FMB130 Product Change Notifications

Product change notifications (PCN) is the way of informing customers of upcoming changes related to Teltonika products. This includes outward appearance adjustments, hardware improvements, firmware changes, changes to package contents, etc. This page stores information regarding changes to the FMB130 tracking device. Below you will find a list of both upcoming and already implemented changes sorted from newest to oldest (top to bottom).

2021.04.30: Bluetooth® Improvement

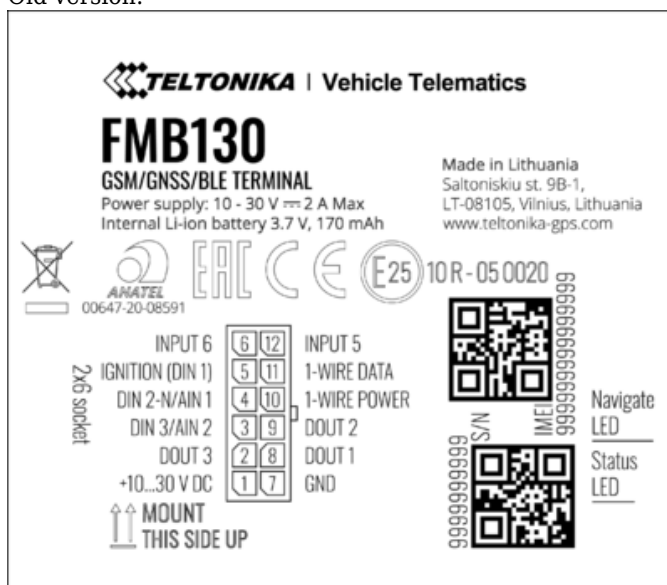
We would like to inform you, that Bluetooth® performance for the FMB130 device will be updated in the factory from October 2021.

Change type	Internal	
Detailed description	Bluetooth® antennas are improved for FMB130 device ensuring better signal strength. The efficiency of Bluetooth® antennas is considerably increased when receiving or transferring data.	
Change reasons	Following the changes, the capabilities of our devices will be greatly improved to provide better performance when Bluetooth® signal is obstructed or longer distance coverage is required	
Product release date	October 2021
